Bulletin No. REL-JD1.30-3 Group No. 1.30

Crankshafts for John Deere 400 Series Four Cylinder Engines. Used on 3010 & 3020 Agricultural Tractors and JD500, JD510, & JD510A Loader/Backhoes

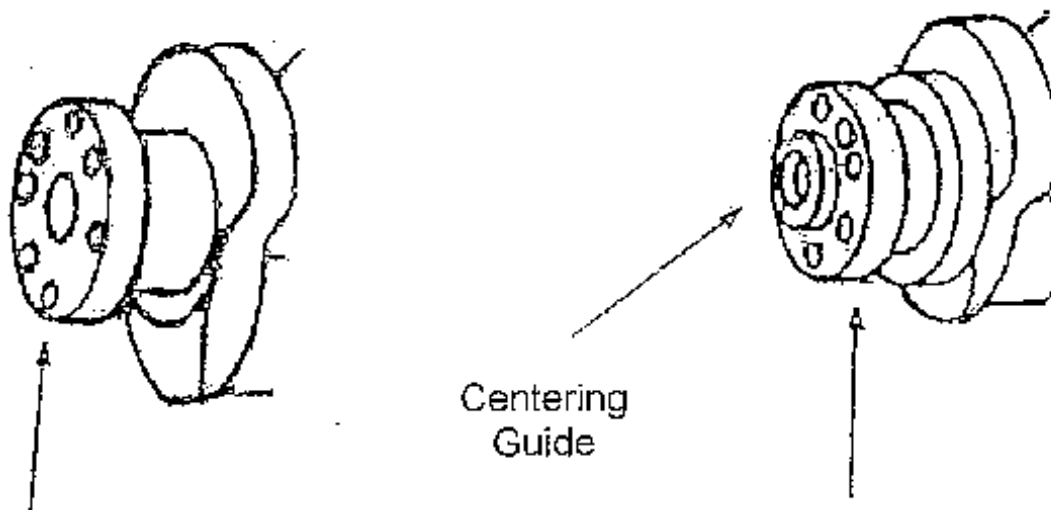
With the addition of 400 Series four cylinder crankshafts to the Reliance parts line, both "early" and "late" versions are available. The difference between the two versions is the hub face of the crankshaft. The late version incorporates a centering guide on the face of the hub for the flywheel. The early version has a hub face that is flat.

Late version crankshafts can be used on early engines provided that the center hole of the flywheel is enlarged to accommodate the shoulder on the face of late crankshafts. The center hole of the flywheel should be machined to (72.01mm) 2.835 inches inside diameter.

Part No. NAR-26428
Early Version
4-270 S/N up to 122,999
Marking No. R26540 or R46498

Part No. NAR-40485
Late Version
4-270 S/N 130,000 and up
Marking No. R40570
